HITACHI SEMICONDUCTOR TECHNICAL UPDATE

DATE	1 December 2000	No.	TN-SH7-280A /E
THEME	SH7729/SH7709A usage notice about DACK when usingDMAC(No.2)		
CLASSIFICATION	<input type="checkbox"/> Spec. change <input type="checkbox"/> Supplement of Documents <input checked="" type="checkbox"/> Limitation on Use		
PRODUCT NAME	HD6417709A, SH7729		
REFERENCE DOCUMENTS	SH7709A Hardware manual SH7729 Hardware manual	Effective Date	Eternity
		From

figure 2. An example of the timing diagram that DACK is incorrectly asserted (the case that A6TEH is 3'b010)

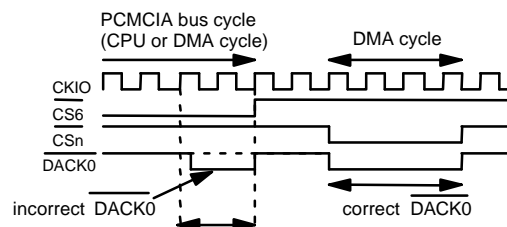
When a PCMCIA bus cycle is followed by a bus cycle with asserting DACK0/1, DACK0/1 may be incorrectly asserted in the PCMCIA bus cycle. The width of incorrect DACK0/1 depends on A5(6)TEH[2:0]. The max width of incorrect DACK0/1 cycle is value of A5(6)TEH[2:0]. This incorrect DACK is independant from whether DACK0/1 is asserted in the PCMCIA bus cycle or not.

In the case that A6TEH is 3'b010, DACK is asserted at most 2cycles.

Work around of (B)

- Please fix DACK to high during PCMCIA bus cycle.
